Company	Trenz Electronic GmbH
PCN Number	PCN-20190711
Title	TEC0850-03-* SPI Flash Change
Subject	BOM change
Issue Date	2019-07-15

This change affects all Trenz Electronic TEC0850-03 SoMs: TEC0850-03-*

Locate Flash (U24 and U25) on top side of PCB:

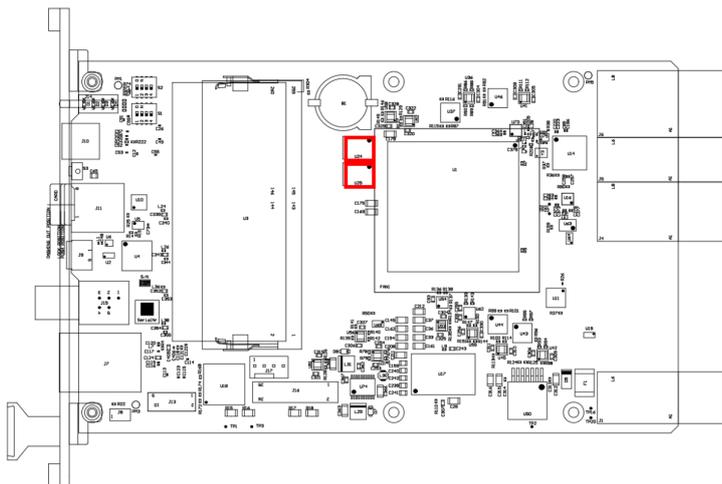
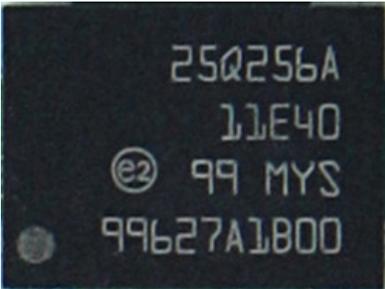
#1 Change SPI Flash from N25Q512A11G1240E to MT25QU512ABB8E12-0SIT

Reason: N25Q512A11G1240E became obsolete.

Impact: None. Both have same JEDEC ID BB20h and manufacturer ID 20h.

old	new
N25Q512A11G1240E	MT25QU512ABB8E12-0SIT
